JAGUAR CARS

RE: Jaguar Recall Campaign R955-NHTSA Campaign # 04V-460

ADMINISTRATION BULLETIN

Fuel Cap Filler Cap Seal Durability –
Revised Seal Ring –
RECALL R955

ILLUSTRATION 1

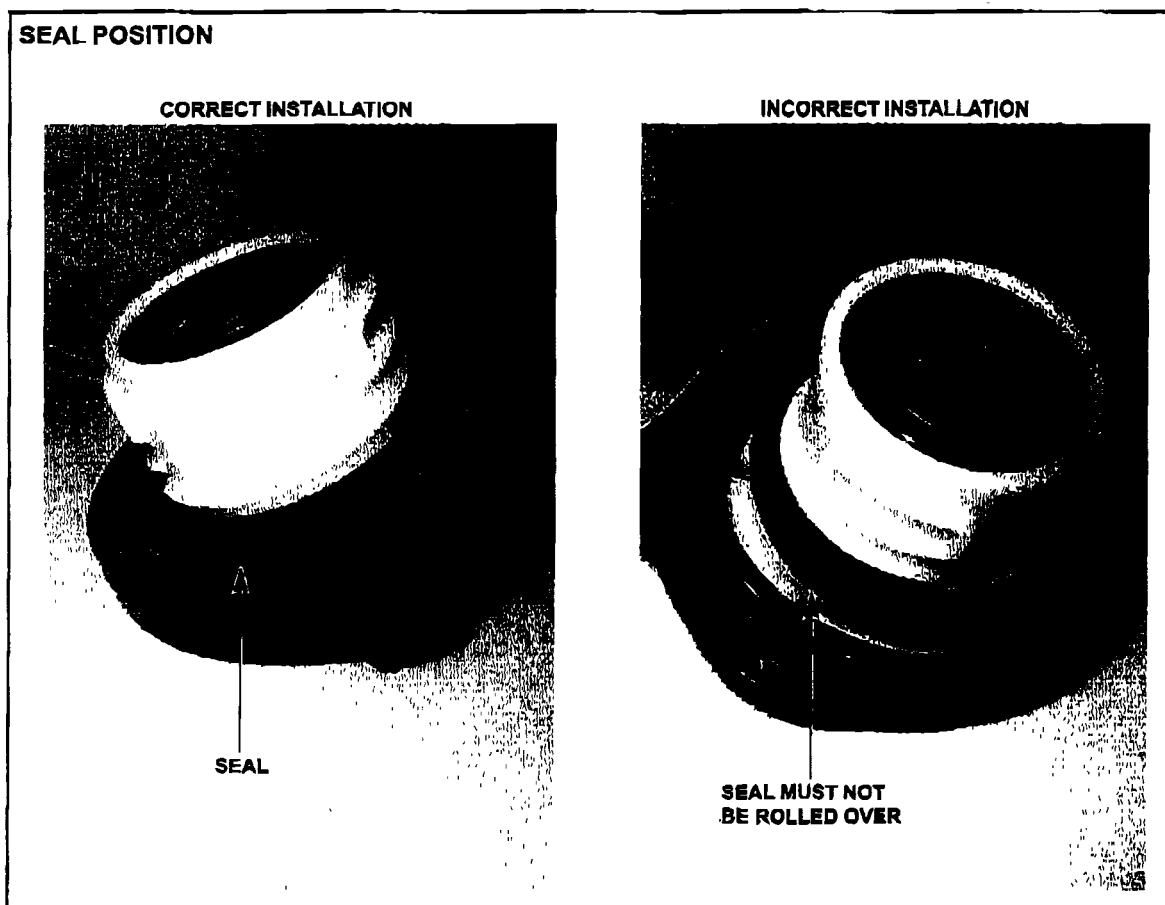
A concern has been identified on a number of 2004 MY X-TYPE vehicles. The fuel tank filler cap seal is soft and does not provide an adequate or durable seal, resulting in fuel vapor escaping and illumination of the Malfunction Indicator Lamp (MIL) on the instrument panel. In the event of a vehicle roll over, it is possible for fuel to leak past the fuel cap. Fuel leakage in the presence of an ignition source can result in a fire.

Jaguar Cars has made the decision to recall 2004 MY 2.5 liter and 3.0 liter X-TYPE vehicles, listed in this bulletin, to replace the fuel tank filler cap seal.

1. Open fuel filler flap.
2. Unscrew fuel filler cap.
3. Remove seal using a suitable pick.
4. Install fuel filler cap seal. Make sure that the seal is fully seated and that the seal is not twisted.

5. Install and tighten fuel filler cap.
6. Close fuel filler flap.
